PFA Grant Amendment Request

Yes. The recently completed 90% designs include the following changes from the 60% designs submitted with the grant application. (Changes are indicated on the attached Exhibit C - 90% Plan Set by their associated numbers in this amendment and organized by their relative location within the Project Area):

CONYERS CREEK HABITAT DIVERSIFICATION AND ENHANCEMENT PROJECT

90% DESIGN SUBMITTAL - REVISION 1

UPPER REACH PLAN
SCALE: 1" = 20'

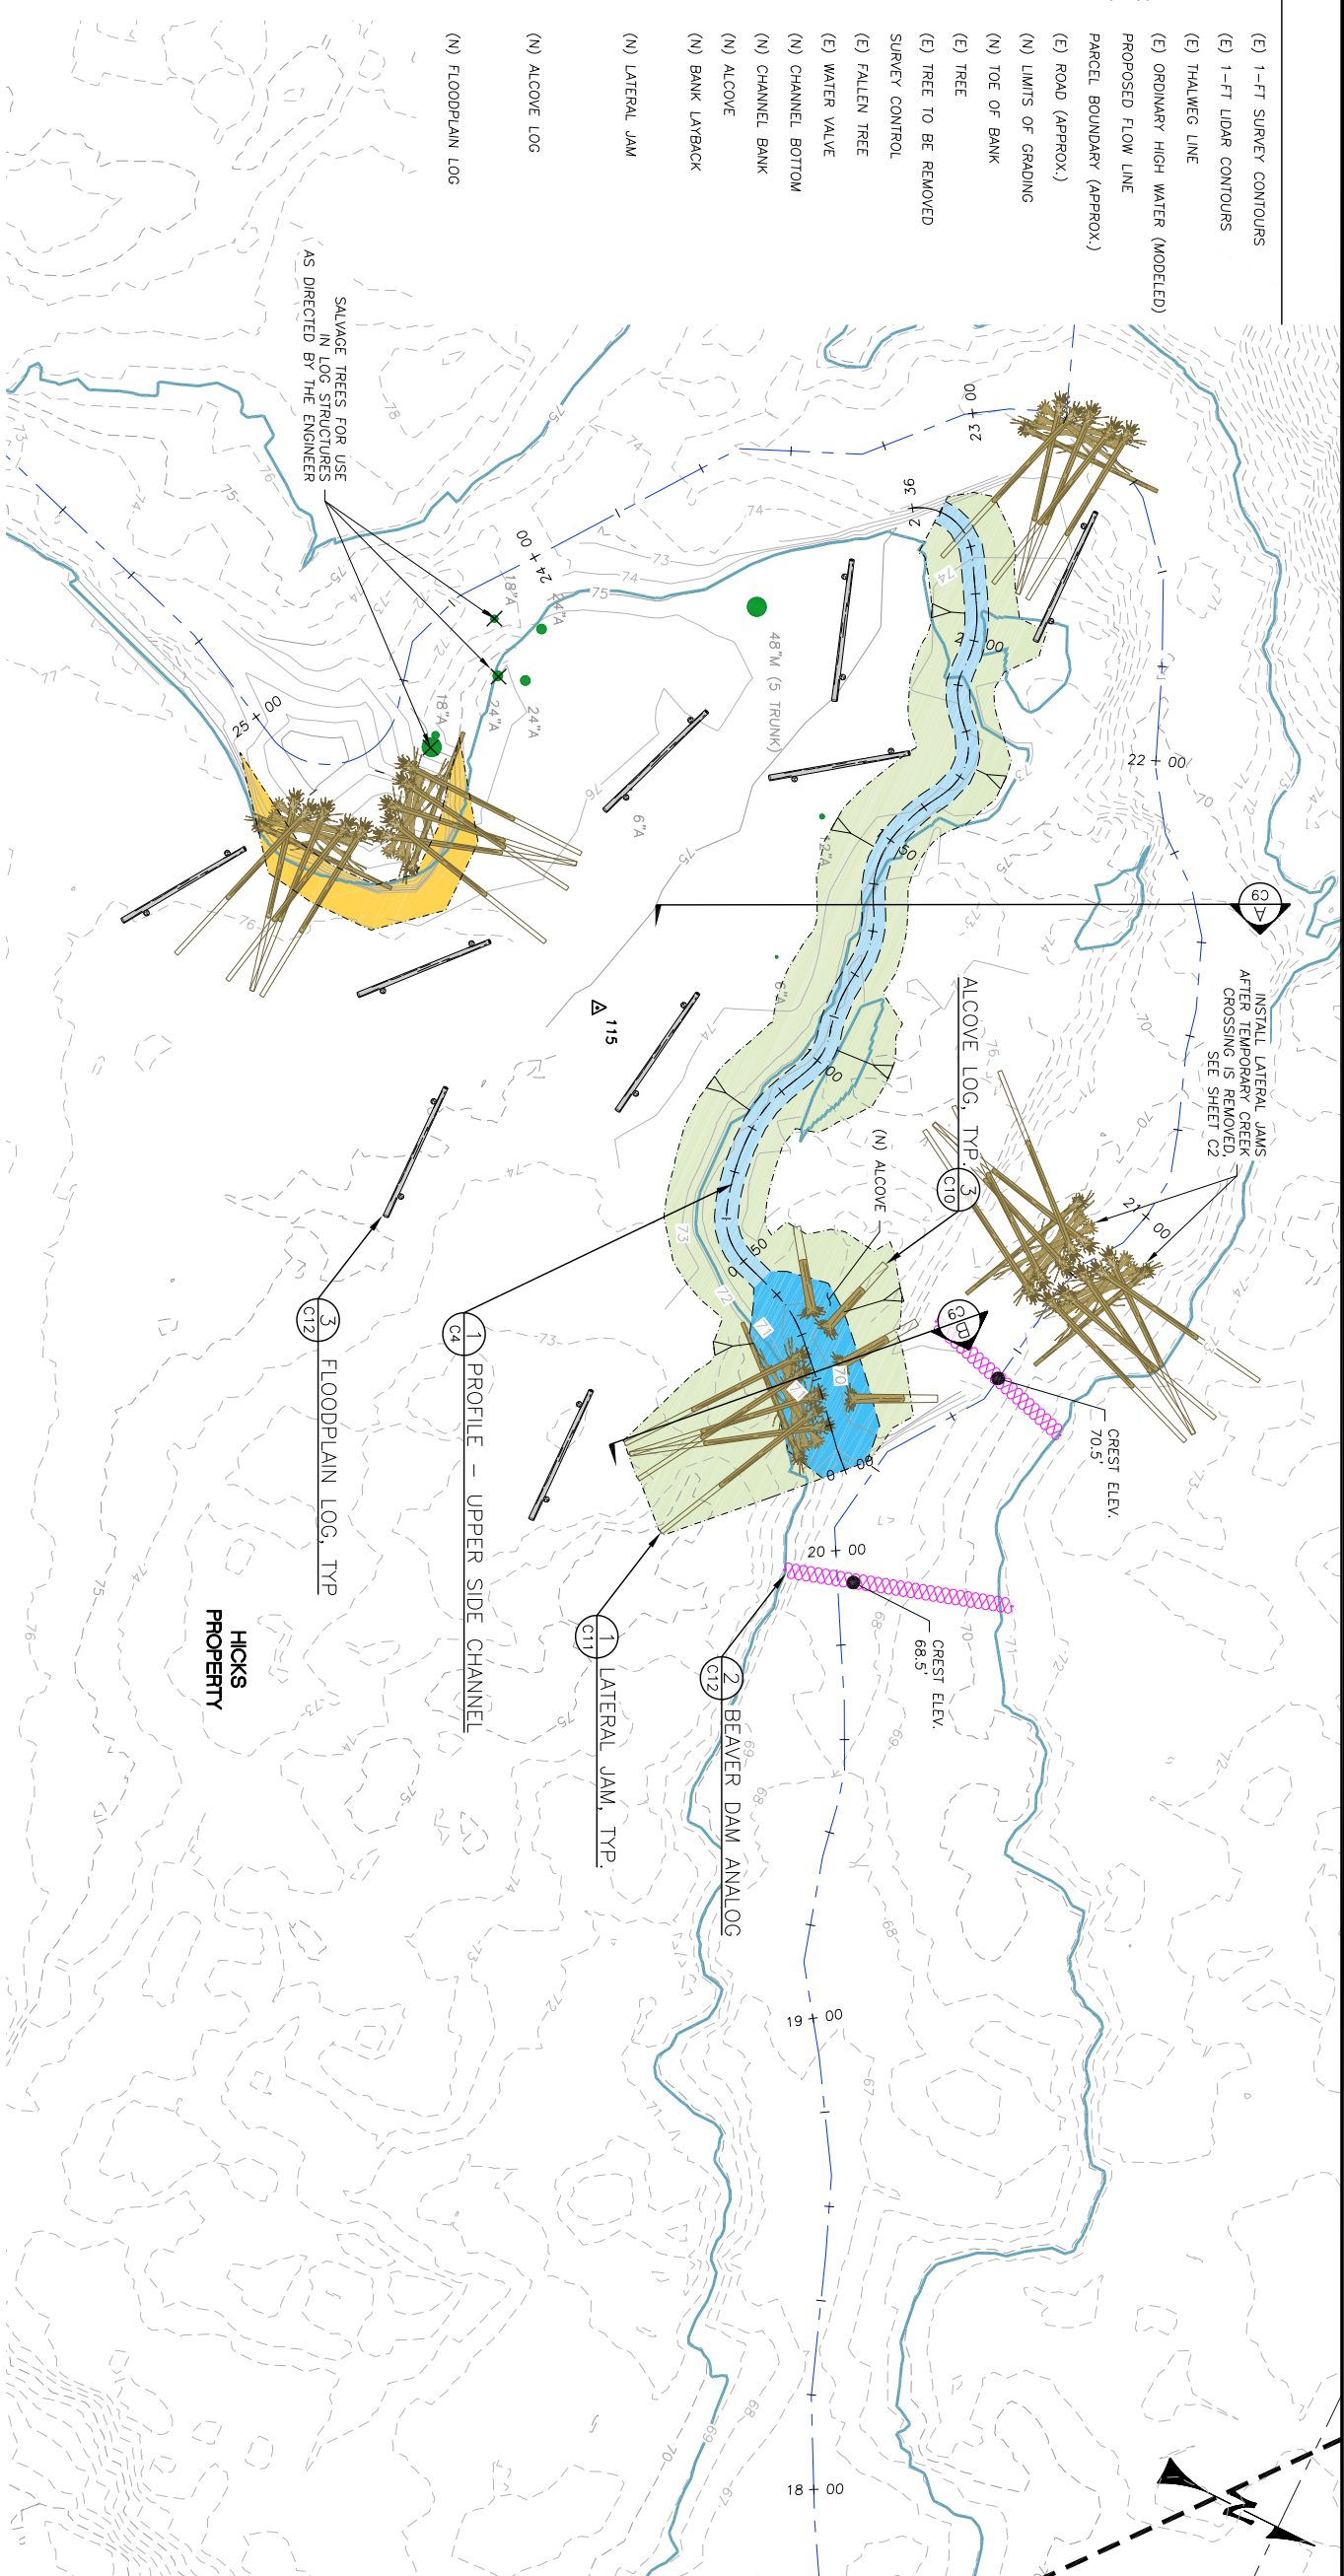
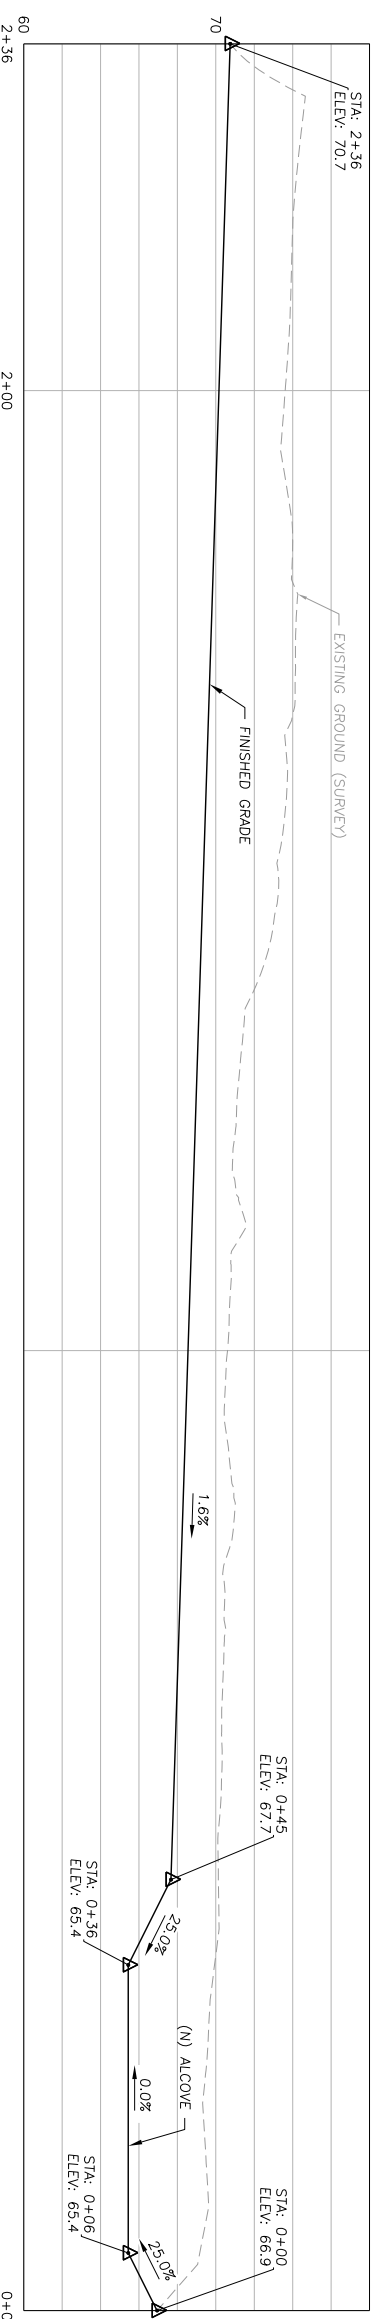
- 1) Added: A log structure has been added to each side of the creek at the temporary stream crossing access site in the "Upper Reach Plan".
- 2) Added: Placement of large Alder logs throughout upstream floodplain area.
- 3) Modified: A complex log structure has been added to the upstream Side Channel C "alcove."
- 4) Added: 2 BDAS will be installed just downstream of the facing log structures in the upstream work site area.
- 5) Removed: The "willow nursery" planting area proposed for the floodplain bench just downstream of the upstream side channel area has been eliminated from the scope of work.

- 1) Add log structures at temporary crossing site. By placing log structures on either side of the stream, a pinchpoint is created, decreasing streampower and forcing water up onto the floodplain more frequently. Greater floodplain inundation and engagement will enhance other project activities in the area, increase flood resiliency, and hopefully improve conditions for native species to establish. Other benefits of this activity include using bioengineered bank stabilization as a prescription for any damage caused by crossing the stream with heavy equipment, and the creation of more favorable conditions for natural and artificial beaver structures to persist.

- 2) Due to ongoing erosion and proposed project activities, several large Alders along the creek will be taken down during the course of construction in the Upper Reach area. There is a high likelihood that these trees may come down on their own prior to project implementation given the undercutting that is occurring. The design team proposes to incorporate this material into log structures for increased detrital inputs and to place larger trunks and branches throughout the floodplain for increased roughness, habitat complexity, and enhancement of beneficial natural processes. Floodplain logs will be secured using wood stakes to prevent movement during storm events.

- 3) The pools located at the ends of Side Channel A and C will receive more large wood pieces for increased habitat value, as well as better protection from predators and solar exposure. The Project Engineer noted high juvenile salmonid use of these habitat features on previous projects, and observed that having a lot of large wood in the pools was critical for protection and shade for rearing juvenile fish.

4) 2 BDAs added into Upper Reach area. Log structures will slow flow velocities through the reach, making BDAs more viable, and creating favorable conditions for structure durability and beaver utilization. Natural dam building was noted in this reach during a habitat survey in the summer of 2024, providing support for the possibility of beaver occupation here.

5) Elimination of "willow nursery" planting area. The project team made the decision to eliminate this planting area in favor of focusing resources installing and maintaining plantings throughout areas disturbed during construction and along streambanks that need revegetation. Funds are better spent ensuring those plantings are successful. Willows will be one of the primary species planted throughout all planting areas particularly close to the water, in floodplain areas, and within log structures and BDAs. Furthermore, recent conversations with DSL staff indicate that permit approval may be made easier through efforts to minimize impacts to wetland areas as much as possible, even if actions are intended to improve condition and function.

MIDDLE REACH PLAN
 SCALE: 1" = 20'

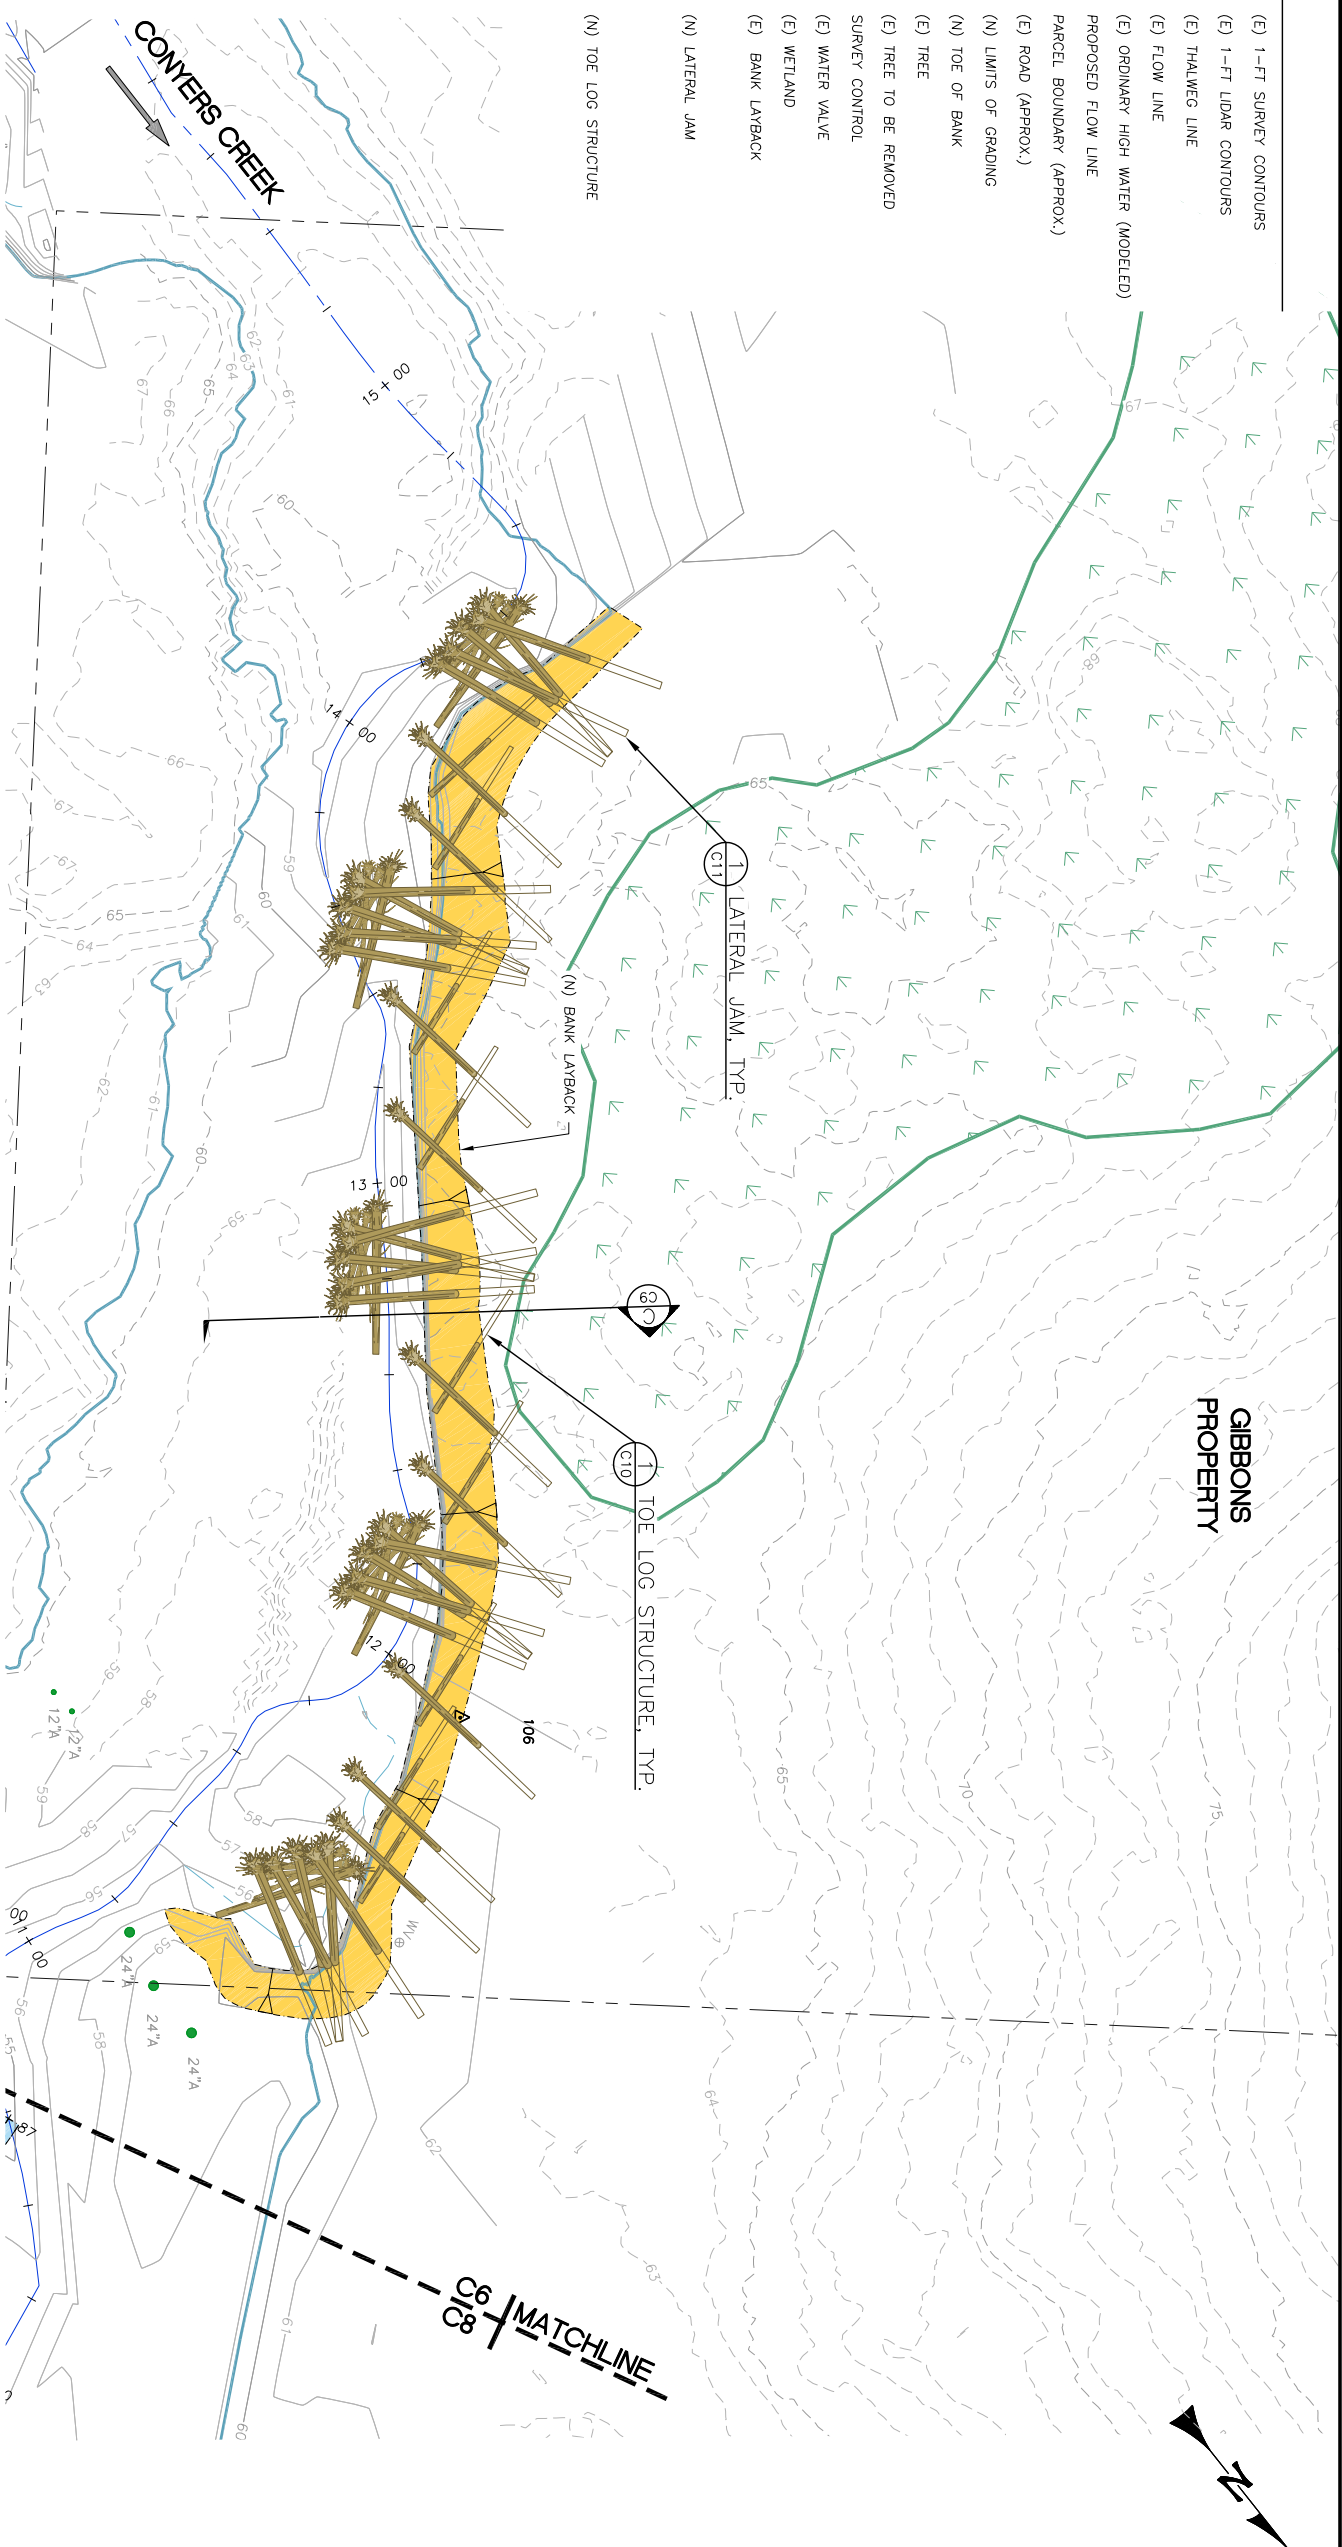
- 6) Removed: The Roaring Creek side channel reconnection has been eliminated from the scope of work.
- 7) Removed: The ~0.2 acre upland wetland enhancement in the Gibbon's field has been removed from the scope of work.
- 8) Modified: The log structure design along the original bank layback area has been modified to include 4 complex log structures that protrude into the stream channel ~ 50% of its width as well as a row of rootwads installed against the bank.

6) Elimination of the Roaring Creek side channel reconnection element. Over the last several winters (and especially during the most recent winter) Conyers Creek has experienced severe erosion in this area which has eaten away at the space required to rebuild and reconnect the historic Roaring Creek channel. Elimination of the Roaring Creek reconnection also results in the elimination of the 6 BDAs that were originally planned for installation in the reconnected channel.

7) Upland wetland enhancement removed from scope of work. Recent conversations with DSL staff about this activity indicate that grading activities would trigger required mitigation for the impacts to the current wetland (despite its degraded state) and expensive monitoring of both the "restored wetland" and proposed mitigation site. Based on that information, it was decided that the landowner would instead work with NRCS regarding wetland enhancement in that area. The landowner currently has an active EQIP contract with NRCS that includes funds for weed control and planting work in the wetland, so transitioning this element of the project work to NRCS is logical and simplifies roles.

8) Modification to large wood design along original bank layback area. Small adjustments have been made to the log structure design in this area. Changes reflect the objectives of protecting the streambank, reducing stream power through the reach, providing in-stream refuge and habitat, and directing water onto the adjacent floodplain and into relic channels at more frequent intervals. In an effort to meet these objectives, the design has been modified from 4 complex log structures installed closely to the bank, to a combination of complex log structures that protrude into the stream approximately halfway and a row of single rootwads that line the toe of the exposed bank.
